**Re: Windlectric Inc. - Application for Leave to Construct Transmission Facilities
(EB-2014-0300)**

System Impact Assessment Report (Addendum)

CAA ID: 2011-433
Project: Amherst Island WF
Applicant: Windlectric Inc.

Document ID	CAA 2011-433
Document Name	System Impact Assessment Report (Addendum)
Issue	2.0
Reason for Issue	Addendum Report
Effective Date	May 12, 2015

Figure 1: Updated connection arrangement

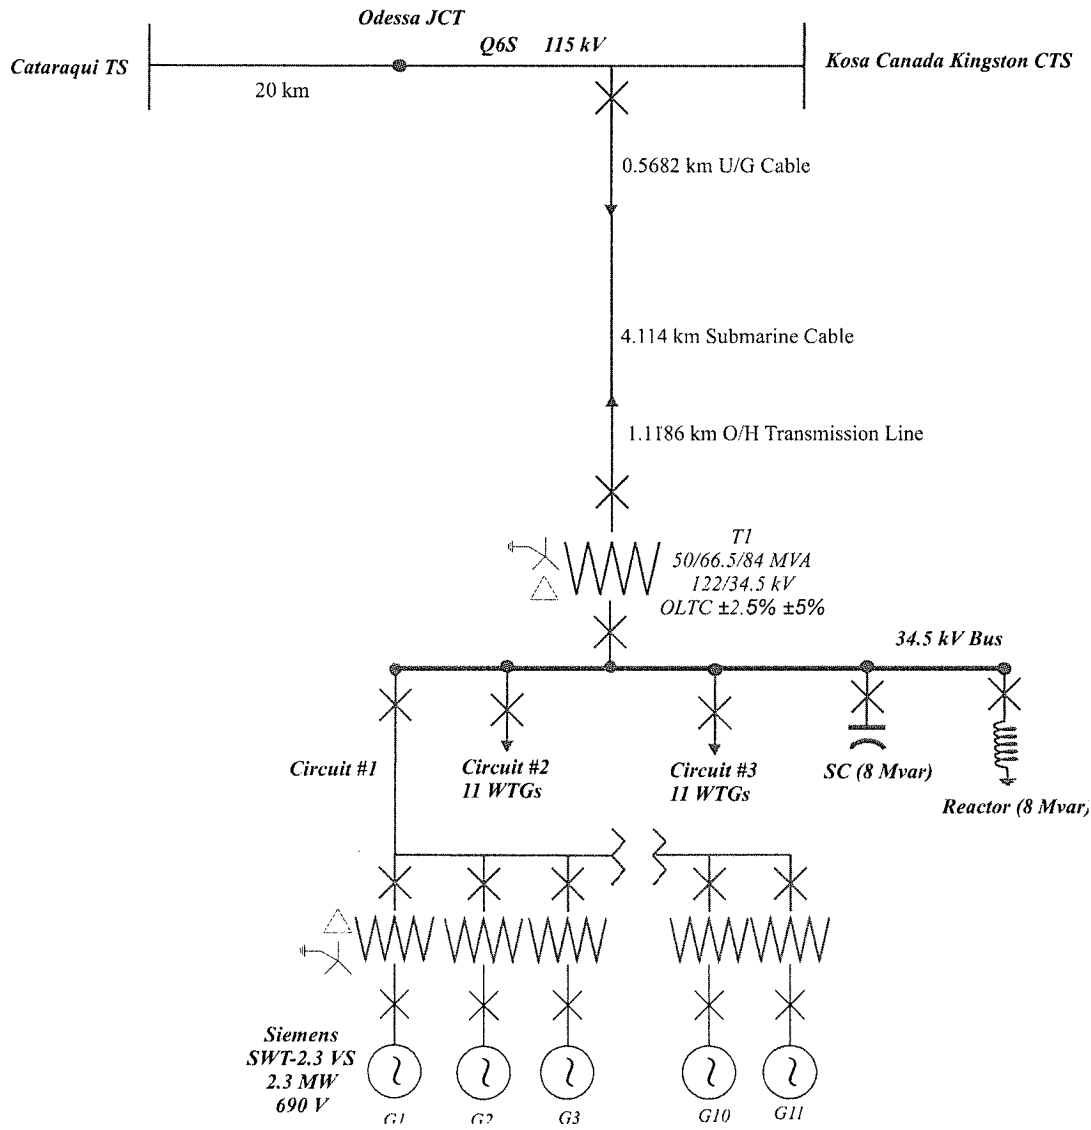
The System Impact Assessment for Amherst Island Wind Farm (CAA ID 2011-433) was completed on April 18, 2012. Recently, the connection applicant has notified the IESO of following change for the project’s 115 kV tap line:

- Install a 1.1186 km overhead line, a 4.114 km submarine cable and a 0.5682 underground cable to connect the project to Q6S.

The updated connection arrangement is shown in Figure 1 below.

Updated Substation Plan

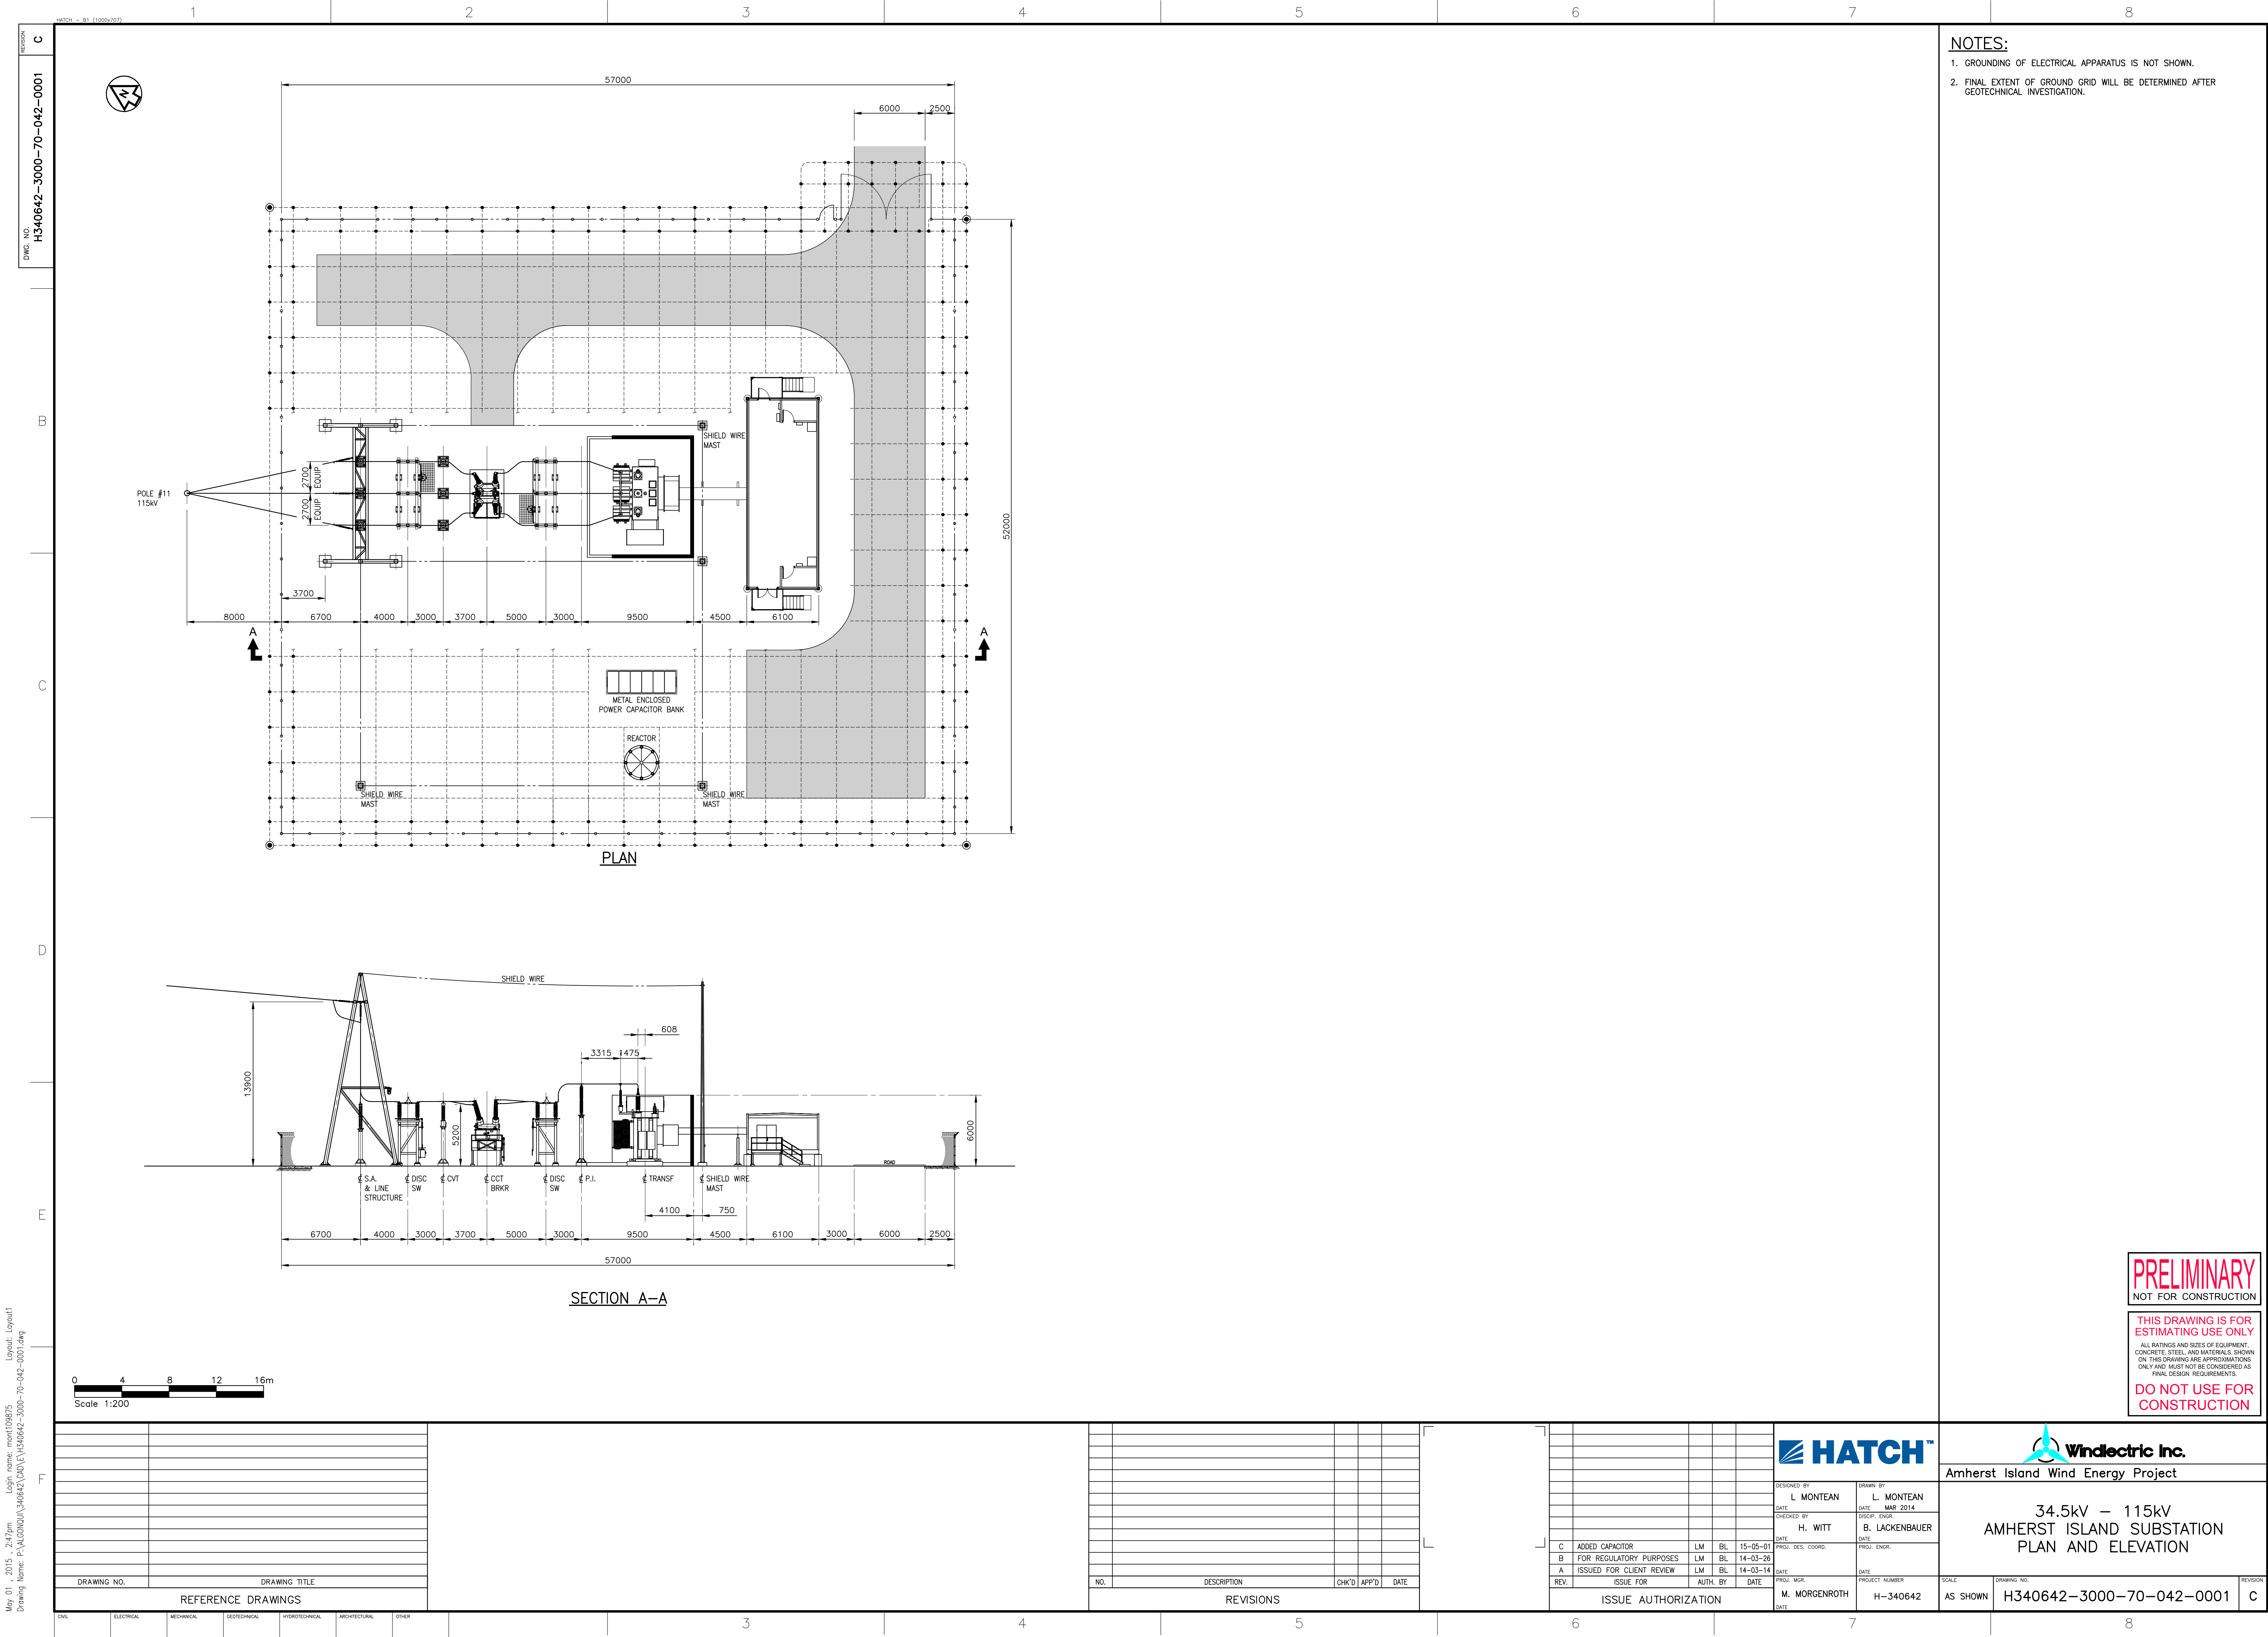
Also enclosed are an updated Single Line Drawing (Schedule 'D') and an updated Substation Plan (Schedule 'E') which address the additional requirements set out in Section 2 of the SIA
